OAKVIEW VENUE GROUP SOLICITATION OF BIDS ATLANTIC CITY CONVENTION CENTER JIM WHELAN BOARDWALK HALL

ADDENDUM #3

For:	
	ATLANTIC CITY CONVENTION CENTER
	LIGHTING CONTROLS UPGRADE
	ELECTRIC CONTRACTORS

ELECTRICAL
LEVEL TWO
LIGHTING PLAN

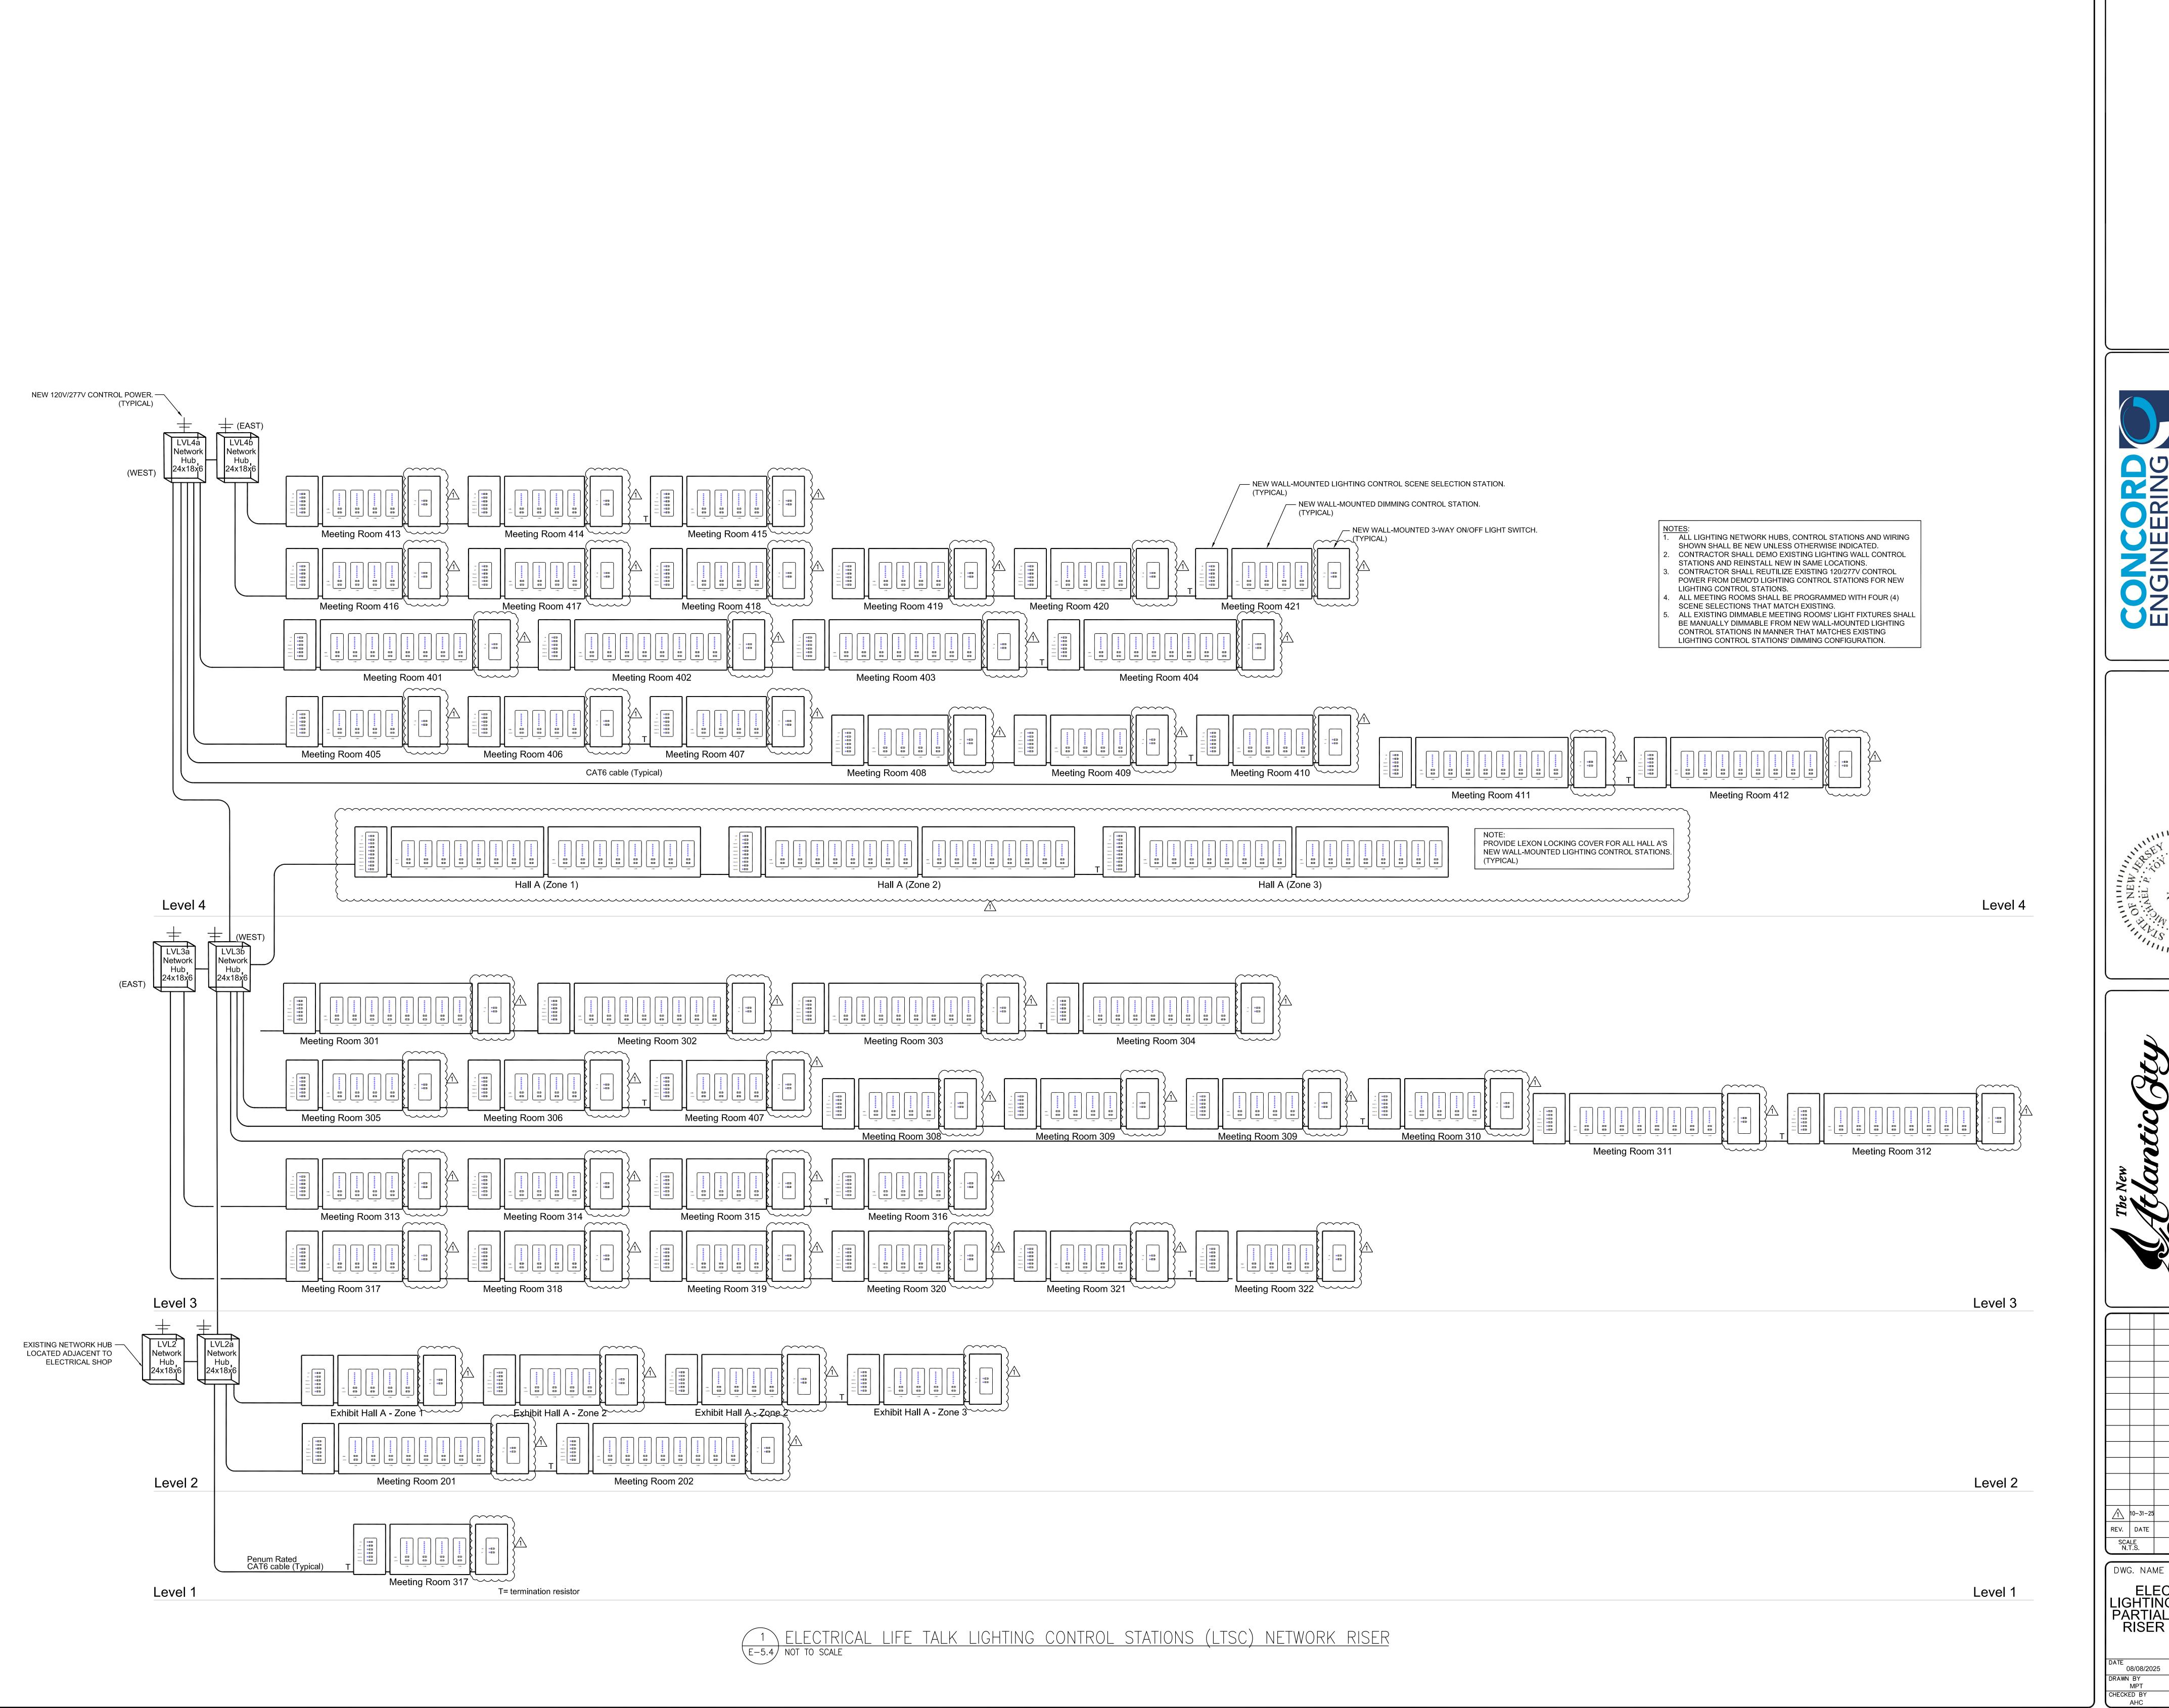
<u>Revised Drawing E-2.5:</u> The low-voltage zoned lighting control wiring and associated zoning has been revised in Hall A.
